#### Seventy-third session

### **Proposal for Supplement 11 to the original series of Regulation No. 99 (Gas-discharge light sources)**

#### **Submitted by the expert from the International Automotive Lighting and Light Signalling Expert Group (GTB)\***

Figure 1  
Category D9S - Cap PK32d-9

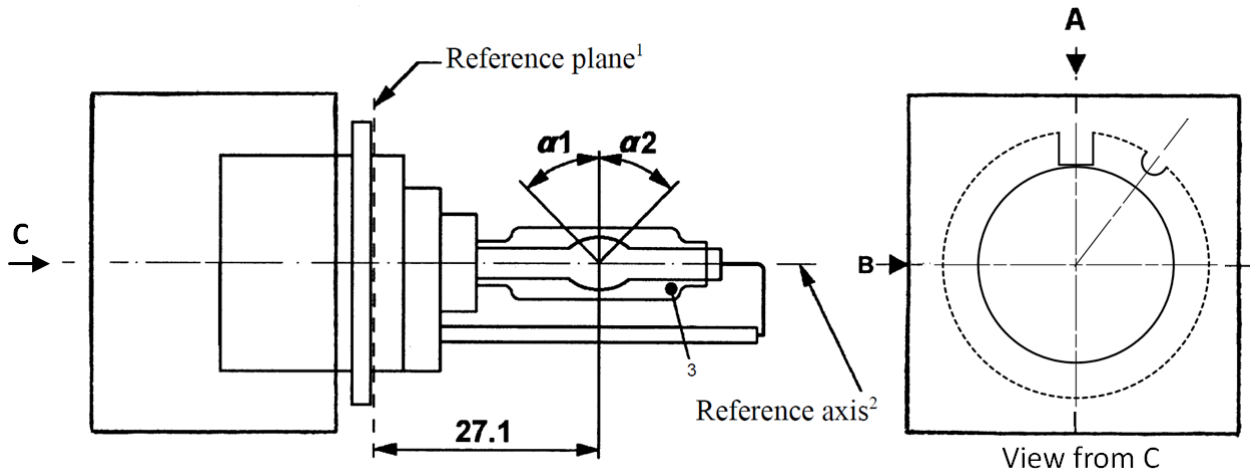
*Insert new sheets D9S/1 to 5, after D8S/5, to read (see following pages; one page per sheet):*

<sup>1</sup> The reference plane is defined by the positions on the surface of the holder on which the three supporting bosses of the cap ring will rest.

<sup>2</sup> See sheet D9S/2.

<sup>3</sup> When measured at a distance of 27.1 mm from the reference plane and with respect to the mid-point of the inner bulb, the outer bulb shall have an eccentricity of 1 mm max.

Position of the electrodes

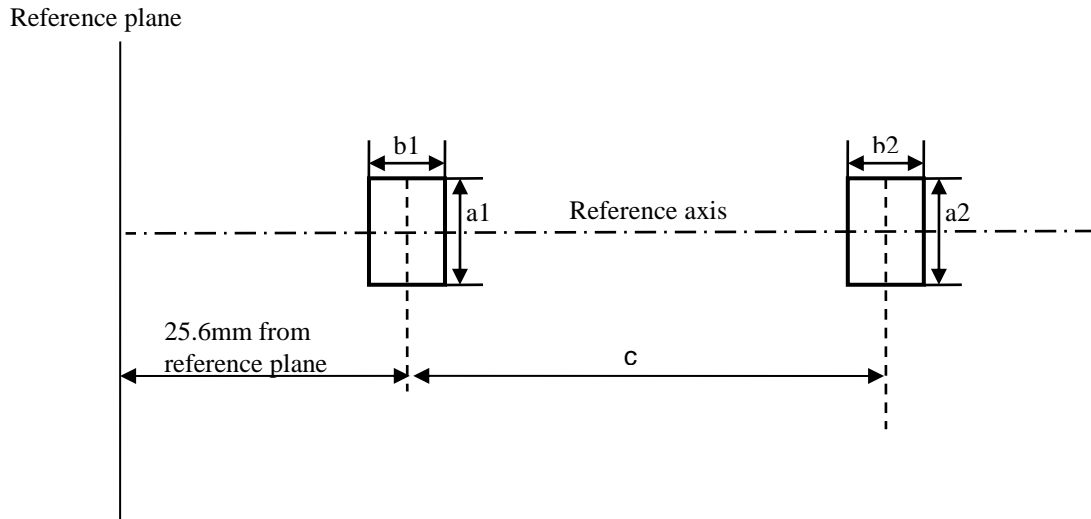
This test is used to determine whether the electrodes are correctly positioned relative to the reference axis and the reference plane.

<i>Dimension in mm</i>	<i>Production light sources</i>	<i>Standard light sources</i>
a1	0.30	0.20
a2	0.50	0.25
b1	0.30	0.15
b2	0.60	0.30
c	3.00	3.00

The arc attachment point to the electrode nearest to the reference plane shall be positioned in the area defined by a1 and b1. The arc attachment point to the electrode furthest from the reference plane shall be positioned in the area defined by a2 and b2. The geometrical data is valid for 27W and 35W operation.

Position and form of the arc

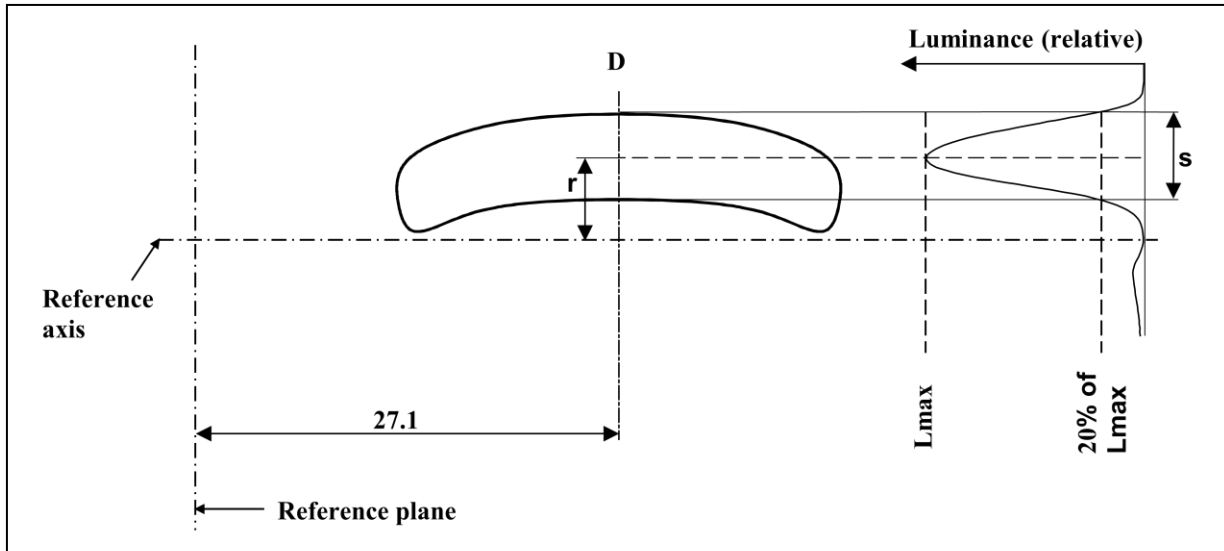
This test is used to determine the form of the arc and its position relative to the reference axis and the reference plane by measuring its bending and diffusion in the cross section at a distance 27.1 mm from the reference plane.

When measuring the relative luminance distribution in the central cross section as indicated in the drawing above, the maximum value shall be located within the distance  $r$  from the reference axis. The point of 20 per cent of the maximum value shall be within  $s$ . The geometrical data is valid for 27W and 35W operation.

<i>Dimension in mm</i>	<i>Production light sources</i>	<i>Standard light sources</i>
$r$ (arc bending)	0.35 +/- 0.25	0.35 +/- 0.15
$s$ (arc diffusion)	0.80 +/- 0.25	0.80 +/- 0.15
